CITY PLAN COMMISSION STAFF REPORT

CD-CPC-2026-00006

Tilden Station Major Amendment

March 4, 2026

1 LANDSCAPING PLAN
 1/8" = 1'-0"

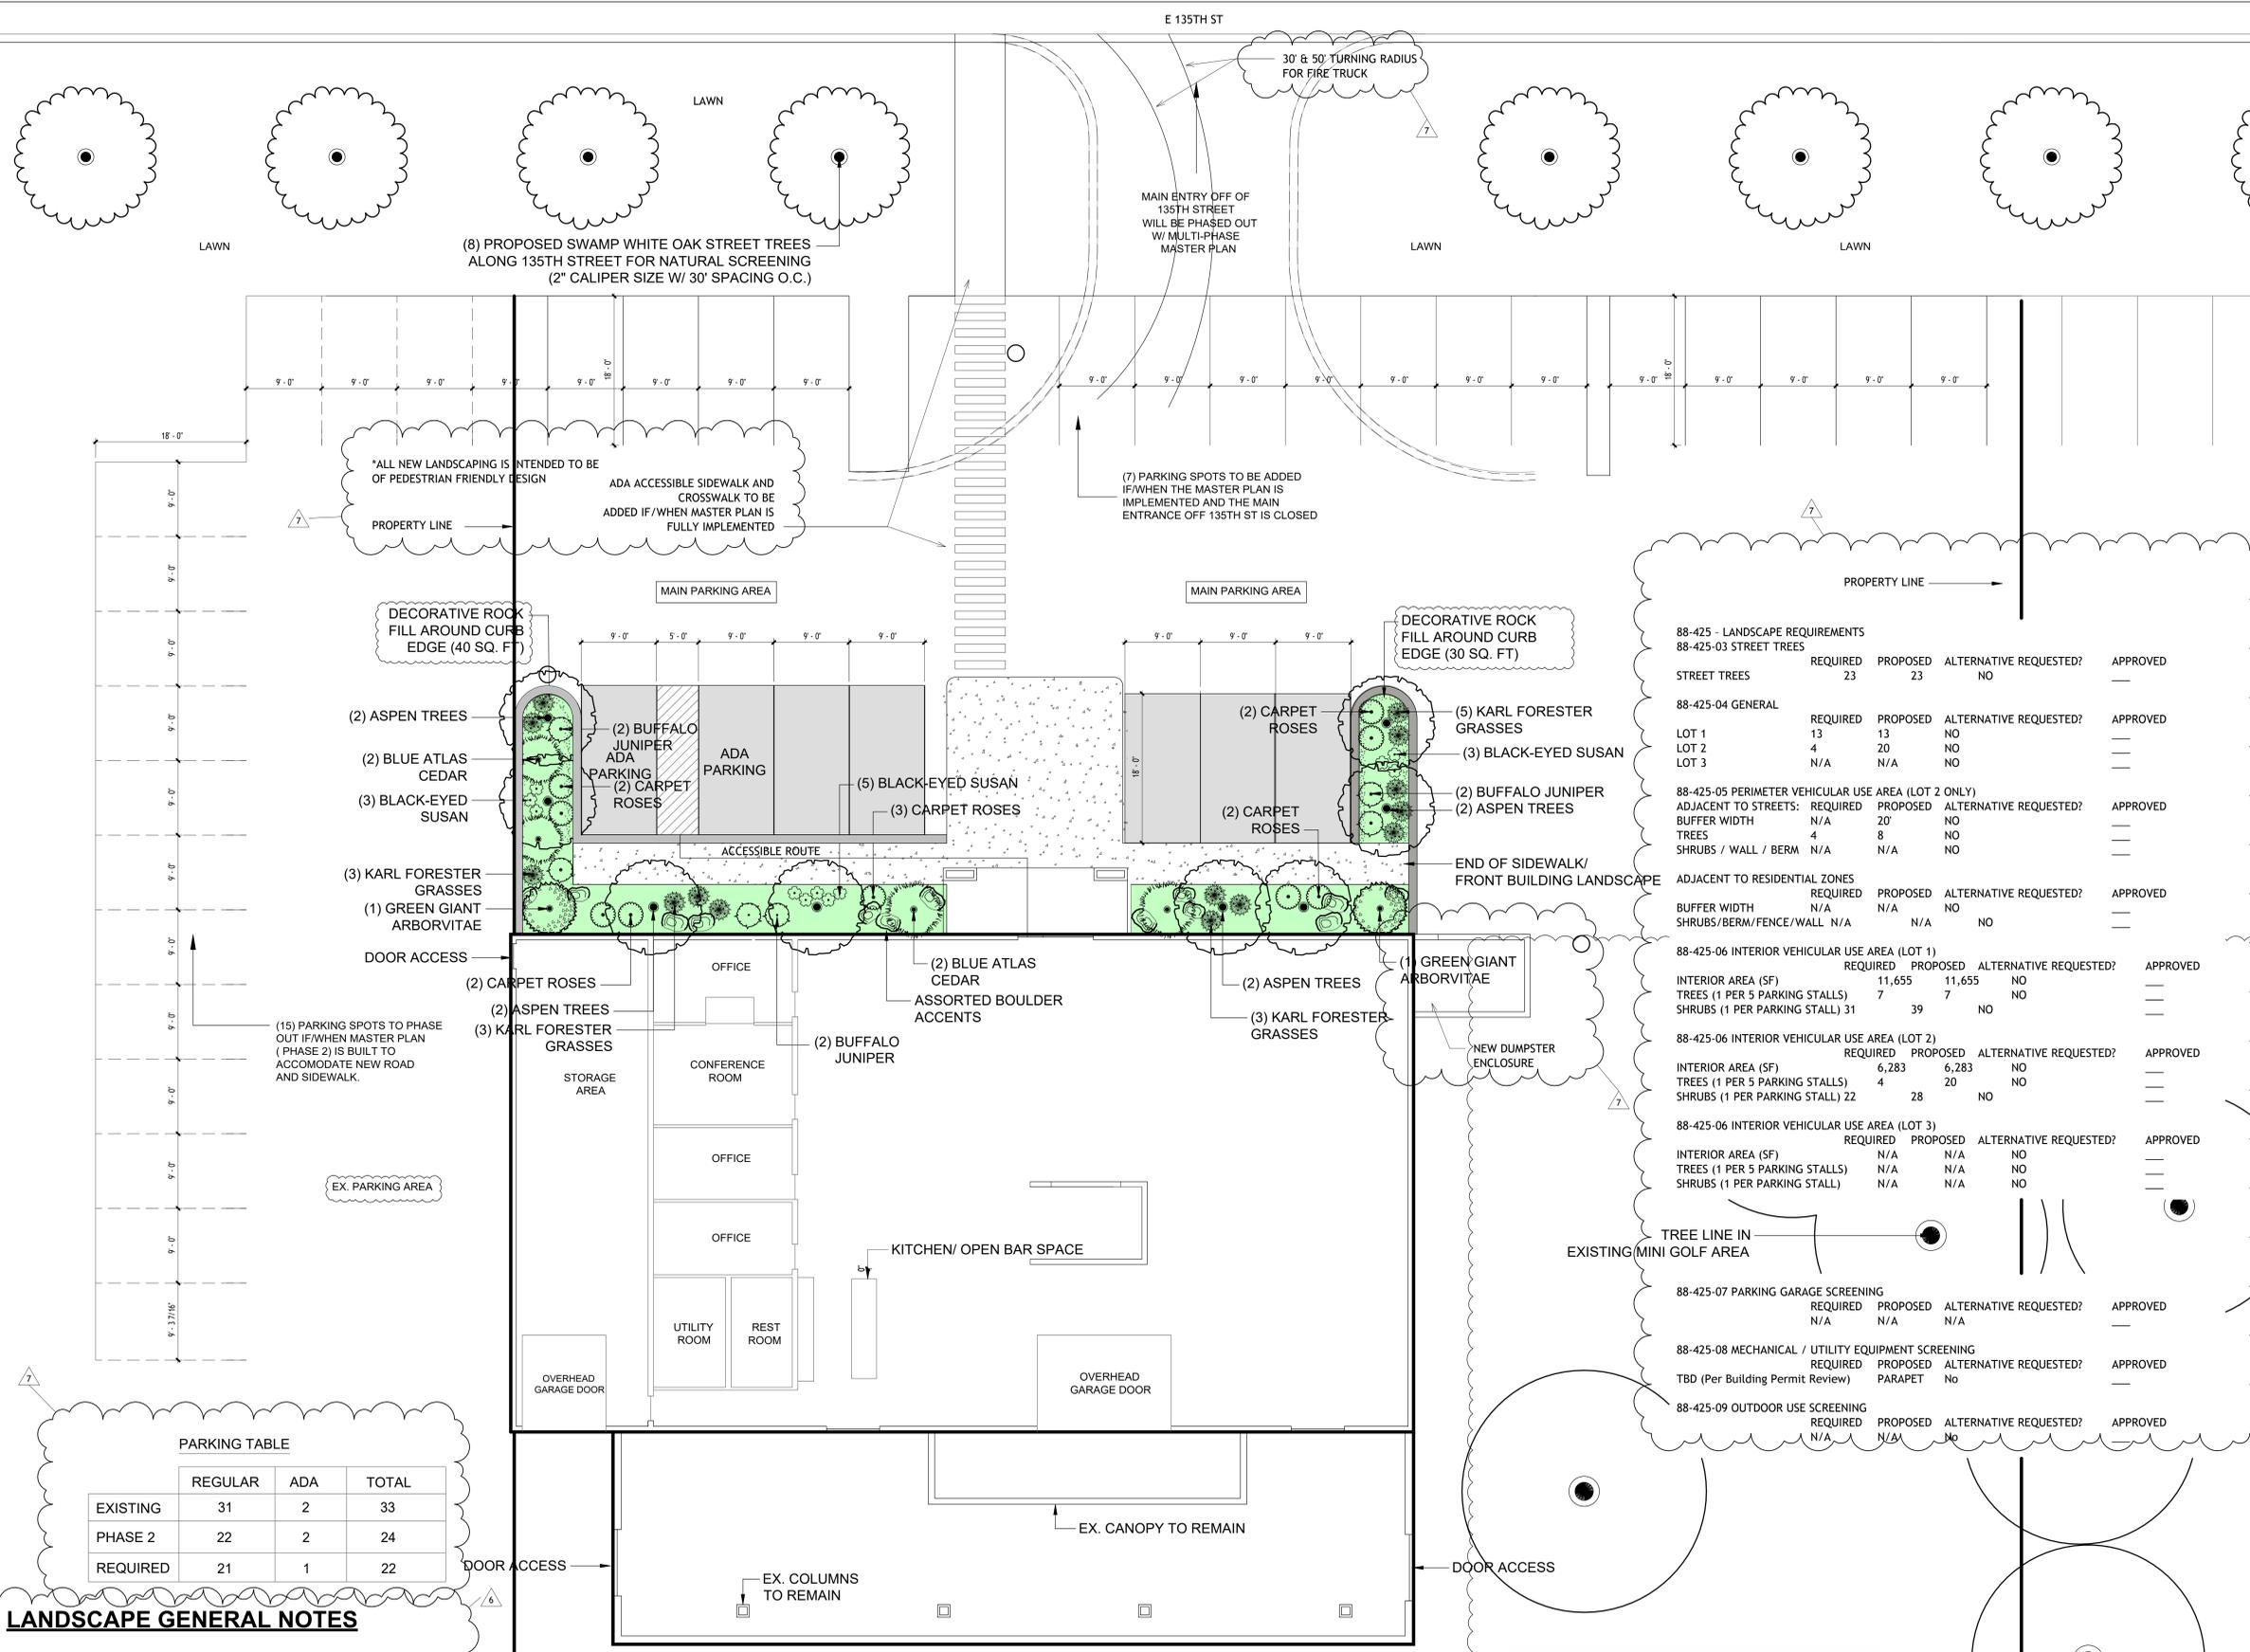
The applicant is proposing landscaping in compliance with code and has provided increased landscaping along the front of the existing building to create visual breaks along the front façade of the building, in lieu of added transparency.

The previously approved design standards for the UR required a specific amount of transparency for buildings along E 135th Street to improve the pedestrian experience. Since the applicant is reusing the building on site, they are proposing robust landscaping along the front of the building in lieu of transparency. Staff is in support of the applicant's proposal to use landscaping to improve aesthetic aspect of the building. The applicant is proposing landscaping on the site in compliance with the zoning and development code.

The applicant submitted landscaping plans showing that no trees will be removed with this proposed use. Future applications for the remaining lots will be required to provide plans identifying trees to be removed.

MARTIN CITY S-1 SITE PLAN

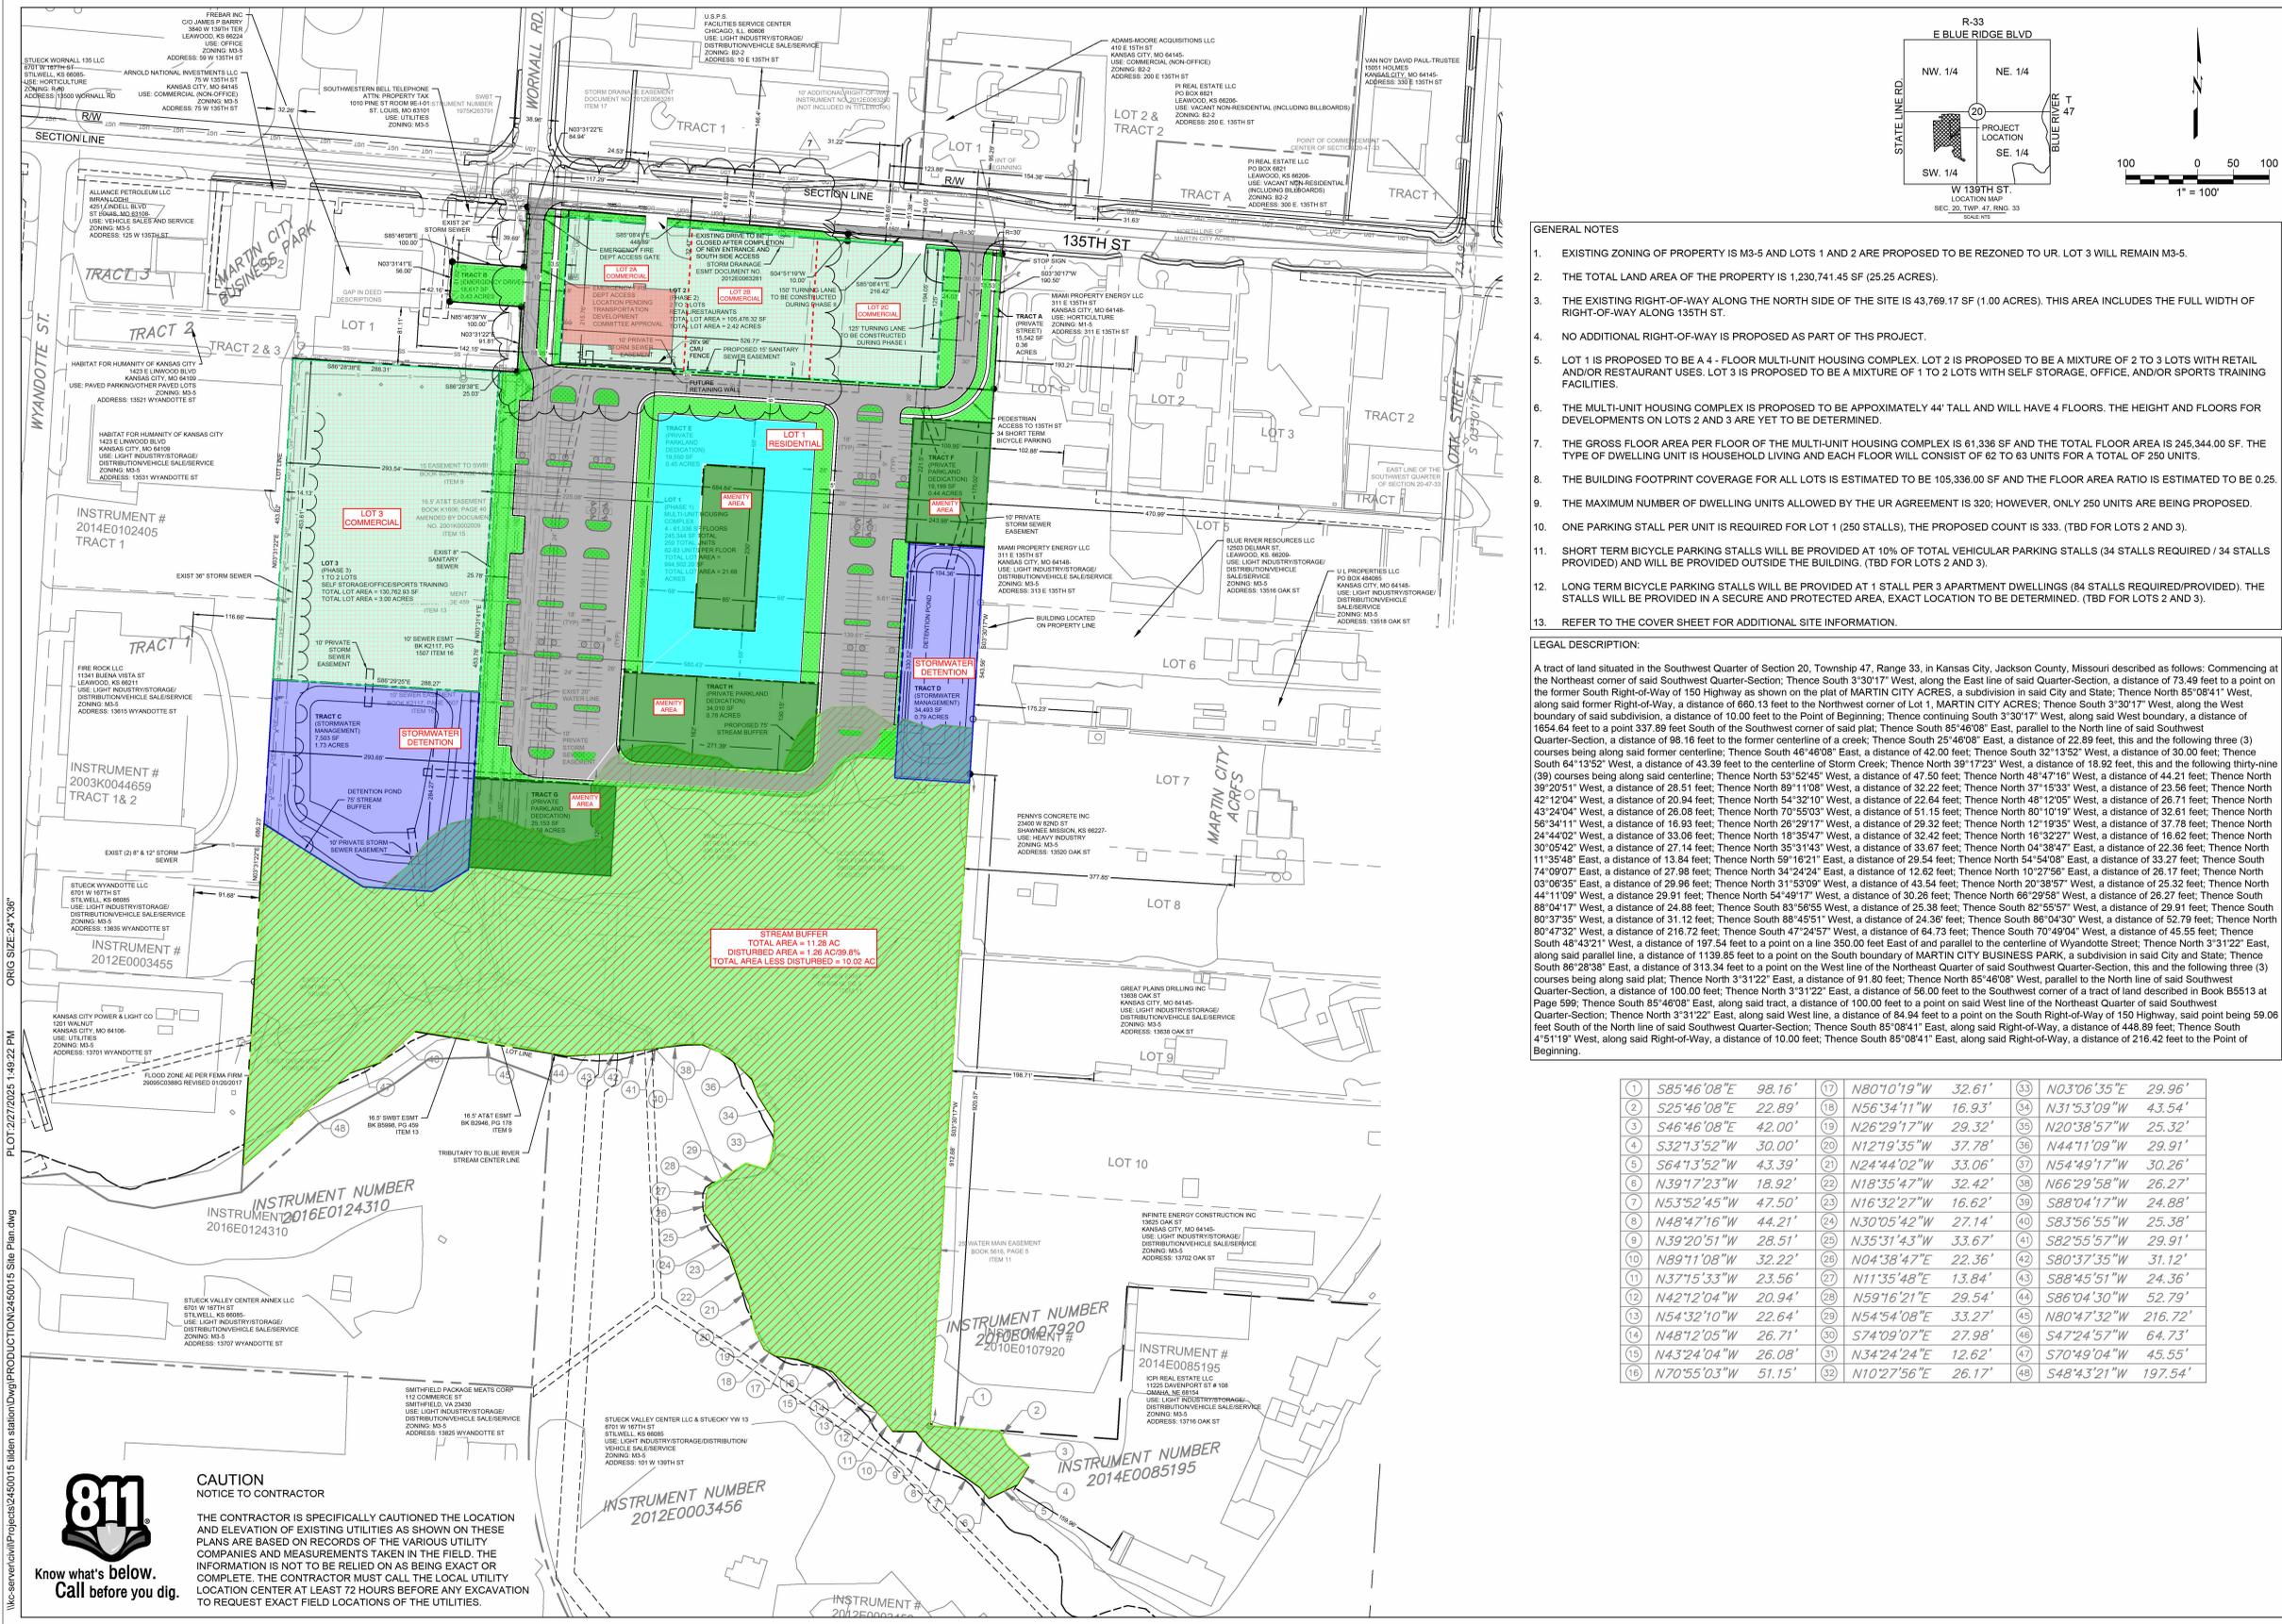
Vehicular ingress and egress provides for safe and efficient movement of traffic on the site and on adjacent roadways. The applicant is using the existing vehicular access points for the proposed use. Any future development for lot 2 or the remainder of the lots will be reviewed at that time.

The plan provides for safe and efficient non-motorized travel opportunities, the applicant is proposing a crosswalk from the building entrance to the sidewalk along E 135th Street.
